FIRE SAFETY INSPECTION REPORT

Factory Name: Kaniz Fashions Limited

ACCORD ID: 23756

Date: 26 Sep, 2019.

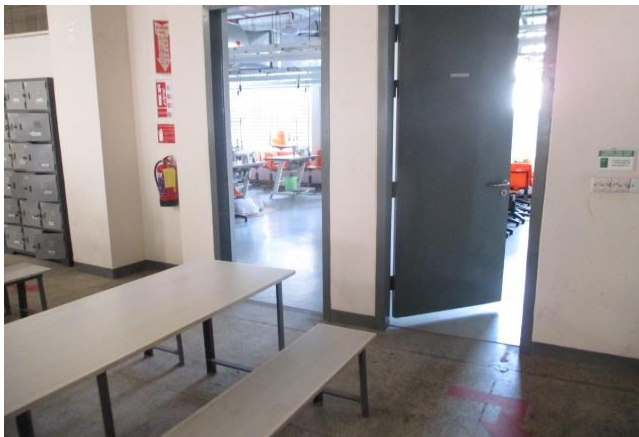
2	Fire Rated Construction	The fire pump room is not provided with adequate fire separation.	Provide fire pump room with 2 hr rated fire separation when not sprinklered and 1 hr rated fire separation when provided with automatic sprinklers in accordance with NFPA 20 Or, Physically separate the pump room from the protected building by a minimum of 50 ft. (15.3 m) in accordance with NFPA 20	Within 3 months
---	-------------------------	---	--	-----------------

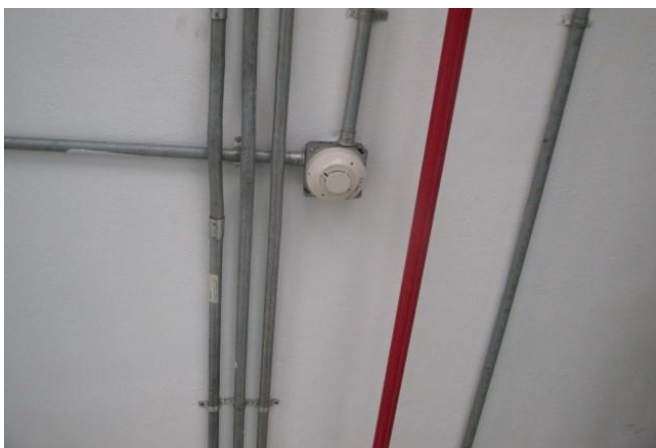
6	Storage in Exit Stair	Storage was located in the exit stair.	Remove all storage from exit stairs.	Immediately
---	-----------------------	--	--------------------------------------	-------------
